**Minutes of the North Carolina Building Code Council  
December 8, 2020  
Raleigh, NC**

**Part A – Administrative Items**

FIGURE R4603.6(d)  
CORNER PILE CONNECTION

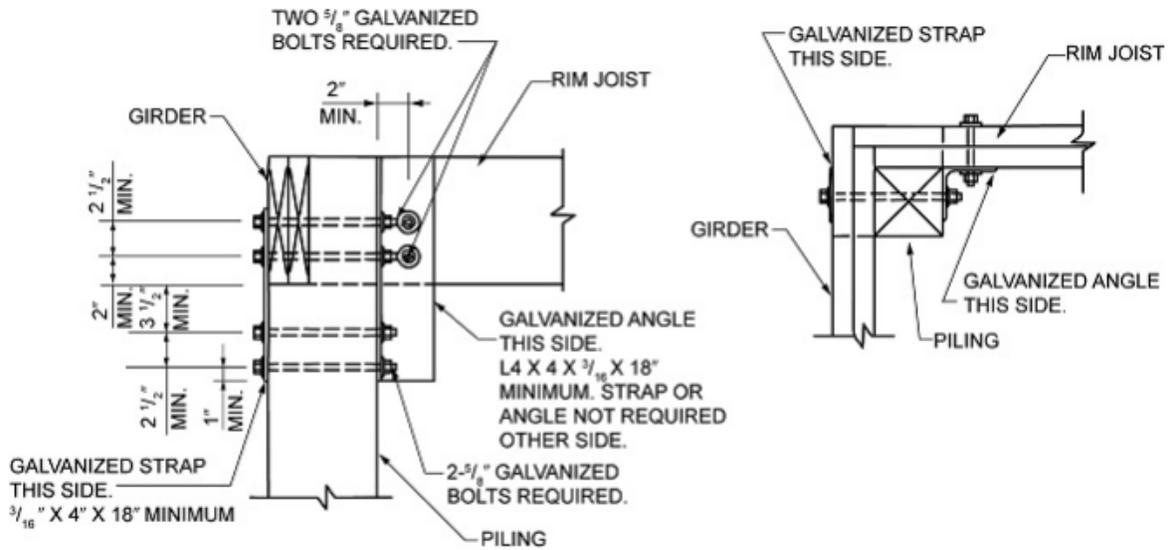
**R4603.6.1 Tying at corners.** At corners, girders shall be connected to the pile with a minimum 3/16 × 4 × 18-inch (5 × 102 × 467 mm) hot dip galvanized strap bolted with two 5/8 inch (15.9 mm) galvanized through bolts on the exterior and a minimum L4 x 3/16 x 1'-6" (102 × 5 × 467 mm) galvanized steel angle bolted with two 5/8 inch (15.9 mm) galvanized through bolts on the interior in accordance with Figure R4603.6(d1), or with a minimum of (2) 3/16" x 4" x 4" x 18" (5x102x467 mm) hot dip galvanized straps installed on the outside of the girders with fasteners per table R4603.6.1 and in accordance with Figure R4603.6 (d2).

<u>Amount Piling is Notched</u>	<u>Associated Figure</u>	<u>Hardware</u>	<u>Fasteners</u>
<u>&gt; 50%<sup>1</sup></u>	<u>R4603.6(d)</u>	<u>one 3/16"x4"x18"</u>	<u>six 5/8" bolts<sup>2</sup></u>
		<u>one L4x3/16x18"</u>	
	<u>R4603.6 (e)</u>	<u>one 3/16"x4"x18"</u>	<u>eight 0.27"x4" each<sup>3</sup></u>

1. Where piling is notched over 50%, use strap as required in Section 4603.6. Install the specified number of bolts or screws in each end of the strap.
2. Bolts shall be 5/8" diameter hot dipped galvanized through bolts with nuts and washers.
3. Screws shall be 0.270" (6.9 mm) minimum in diameter, hot dipped galvanized to a minimum of A153, Class C, and having a minimum length of 4", and also shall be long enough to penetrate at least one inch through the remaining pile and into the girder.

**Residential Super Committee: Motion to approve with correction made by D. Smith. Second by S. Knight. Motion passed.**

FIGURE R4603.6(e)(f)  
ELEVATIONS  
(SHOWING POSSIBLE ARRANGEMENT OF X-BRACING IN LINE) (G AND H SIMILAR)

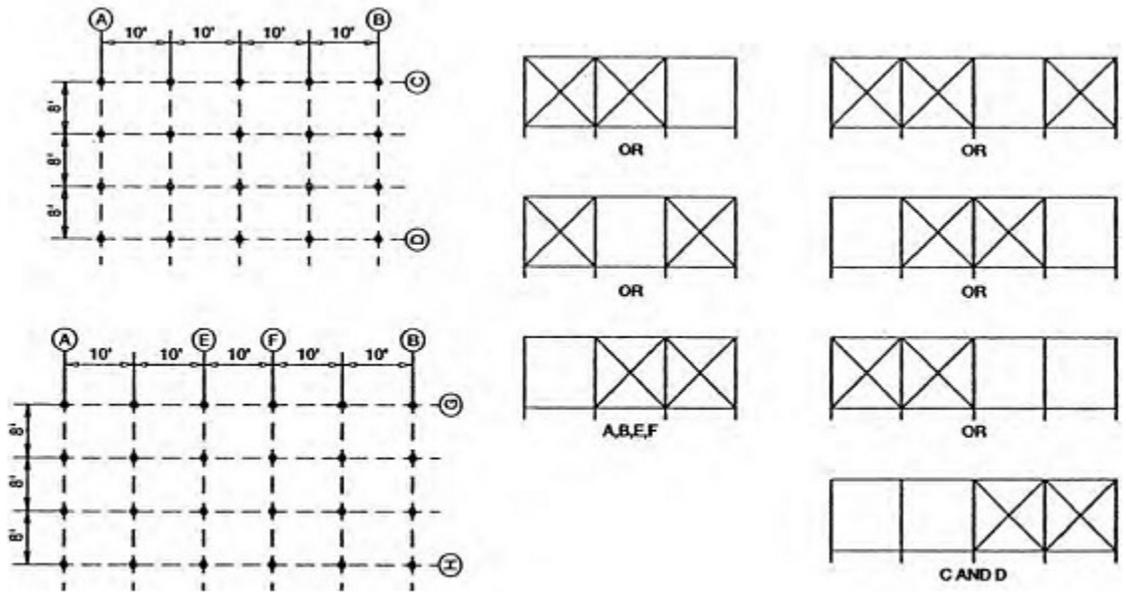
**R4603.6.2 Bracing of Pilings.** Bracing of pile foundations is required where the clear height from ground to sill, beam or girder exceeds 10 feet (3048 mm) or the dwelling is more than one story above piles. A line of X-bracing is defined as a row of piles with X-bracing provided in at least two bays. A line of X-bracing shall be provided at all exterior pile lines. Where the perimeter lines of X-bracing exceed 40 feet (12 192 mm), an additional line of X-bracing shall be provided near the center of the building. See Figure R4603.6(e)(f). X-bracing shall be with 2 × 10s through bolted with two 3/4-inch (19.1 mm) bolts at each end. The code official is permitted to accept alternate bracing designs if they bear the seal of a registered design professional.
